# SAAB 91 SAFIR SERVICE BULLETIN

Number: 91.2.006

Subject: Inspection of installation for operating and locking of the main landing gear.

Figure 1.

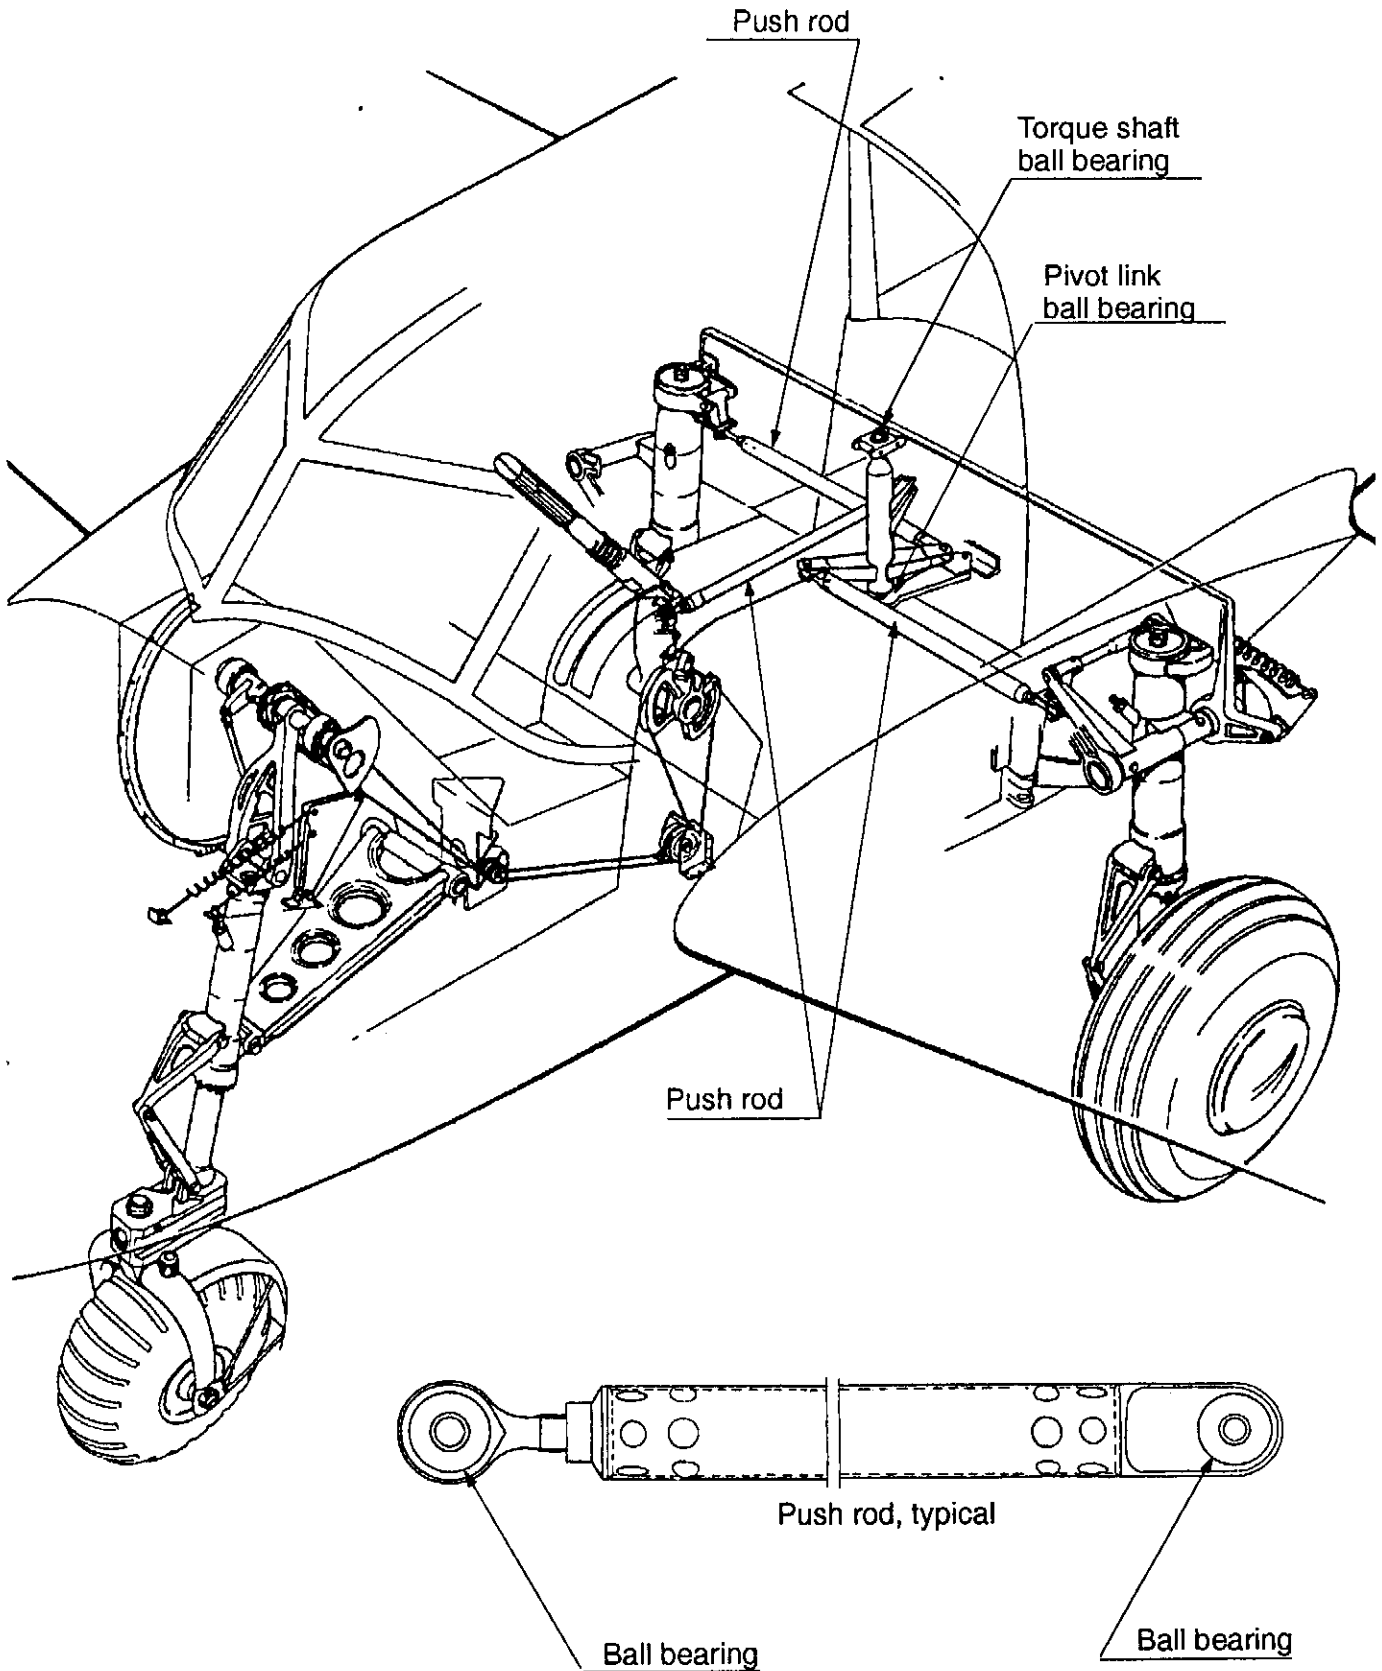
- 1 Remove the pushrods according to figure 1.
- 2 Check that there is no play in the ball bearings.
- 3 Check that the ball bearing dustcovers are undamaged.  
If there are damaged dustcovers and/or bearings with play, new ball bearings shall be installed.

- 1 Check that there is no play in the ball bearing, see figure 1.  
If there is a bearing with play, a new ball bearing shall be installed.

Figure 2

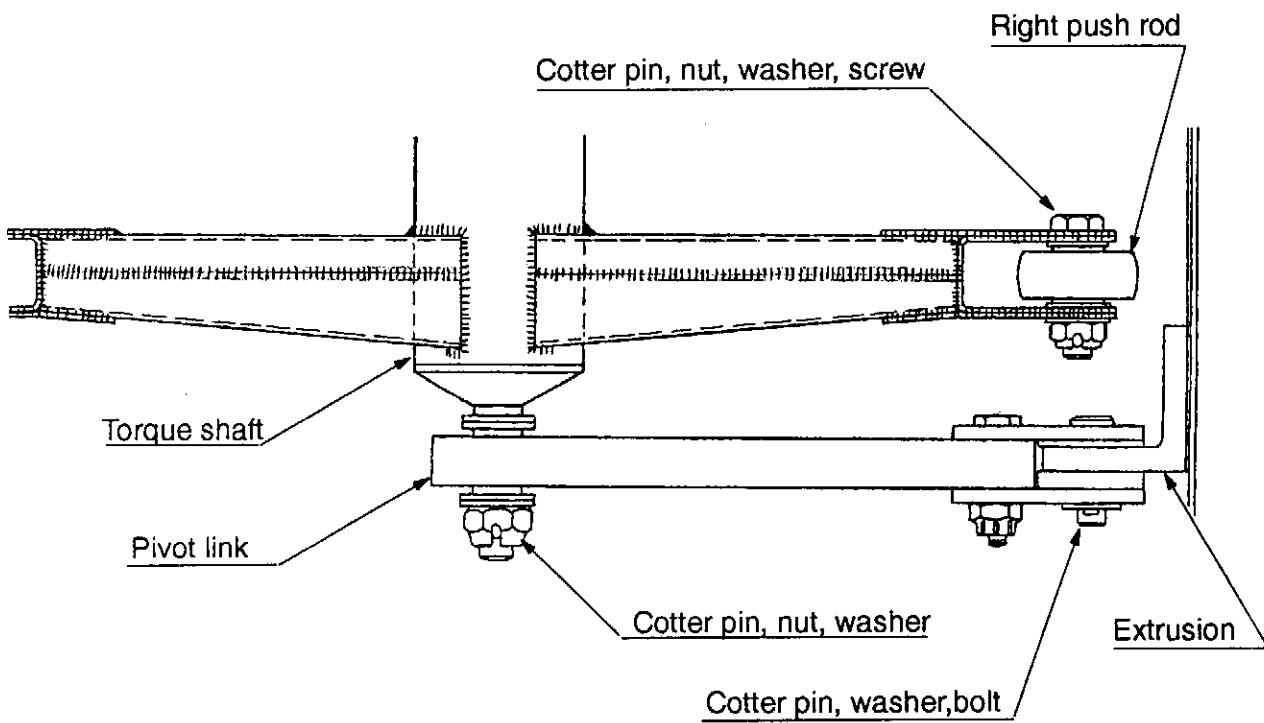
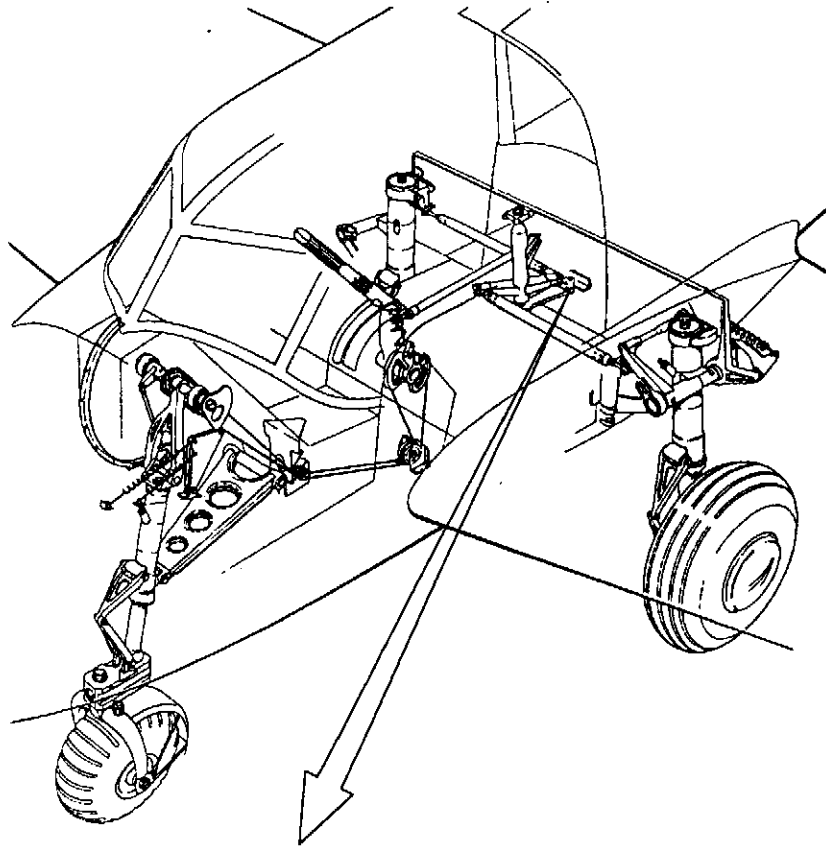
- 1 Check by pulling the pivot link backward and forward that there is no play in the attachment to the extrusion, see figure 2.  
If there is play, the bolthole shall be oversized according to "Oversize of bolthole in the pivot link" and "Oversize of bolthole in the extrusion".
- 2 Remove the pivot link.
- 3 Check that there is no play in the ball bearing.
- 4 Check that the ball bearing dustcovers are undamaged.  
If there are damaged dustcovers and/or bearings with play, new ball bearing shall be installed.

Figure 3

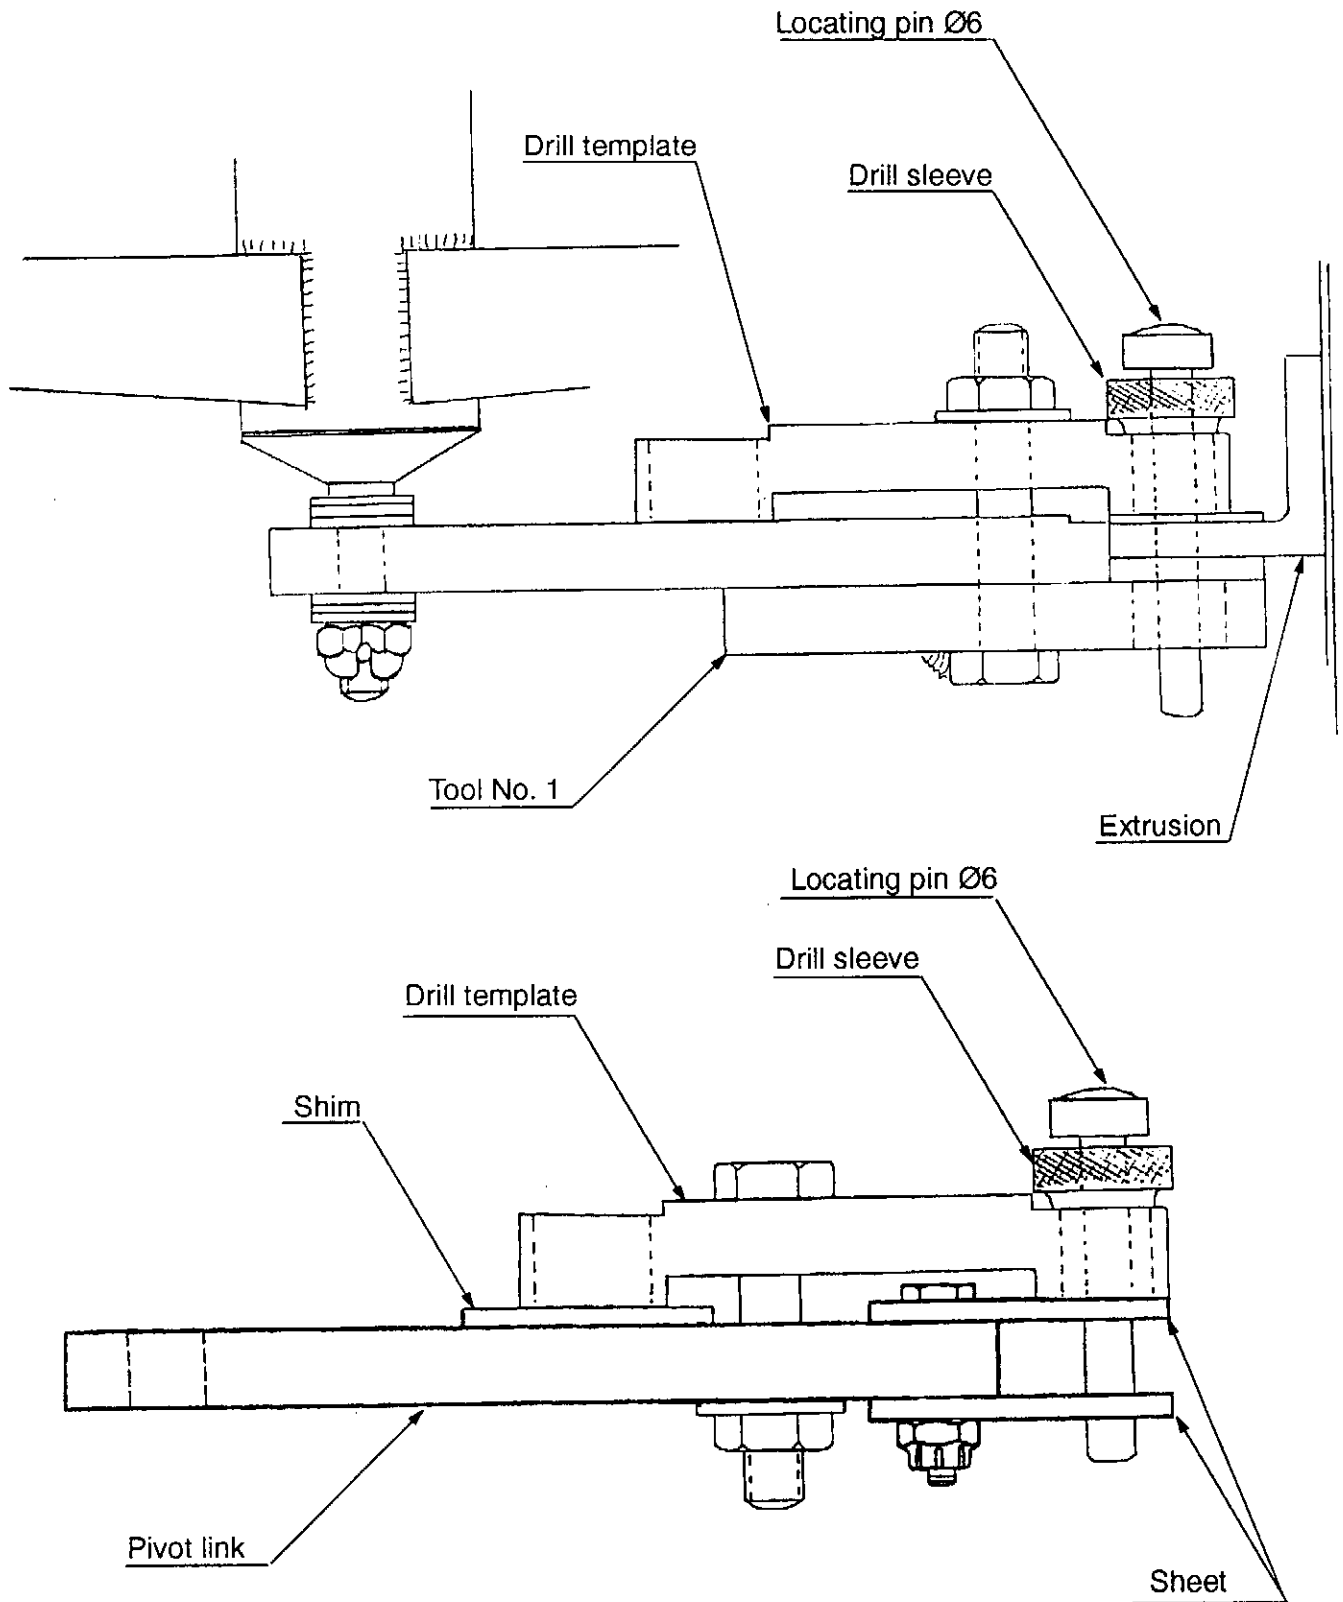
- 1 Install drill template, shim, drill sleeve  $\text{Ø}6$  and locating pin to the hole  $\text{Ø}6$  in the sheets on the pivot link. See figure 3.
- 2 Tighten the drill template to the pivot link. Check that the locating pin does not jam in the sheets and remove the locating pin.
- 3 Drill the hole to oversize by using drill  $\text{Ø}7,7$  with pilot  $\text{Ø}6,0$  and drill sleeve  $\text{Ø}7,7$ .
- 4 Ream the hole to  $\text{Ø}8\text{H}9$  by using reamer and drill sleeve  $\text{Ø}8\text{H}9$ .
- 5 Remove the drill template.

- 1 Install tool No. 1 to shaft with washer and nut.  
Install the drill template over hole  $\text{Ø}6$  in extrusion and install the locating pin  $\text{Ø}6$  according to figure 3.
- 2 Tighten the nut on the drill template. Check that the locating pin does not jam in the extrusion and remove the locating pin.
- 3 Drill the hole to oversize by using drill  $\text{Ø}7,7$  with pilot  $\text{Ø}6,0$  and drill sleeve  $\text{Ø}7,7$ .
- 4 Ream the hole to  $\text{Ø}8\text{H}9$  by using reamer and drill sleeve  $\text{Ø}8\text{H}9$ .
- 5 Remove tool No. 1 and the drill template.
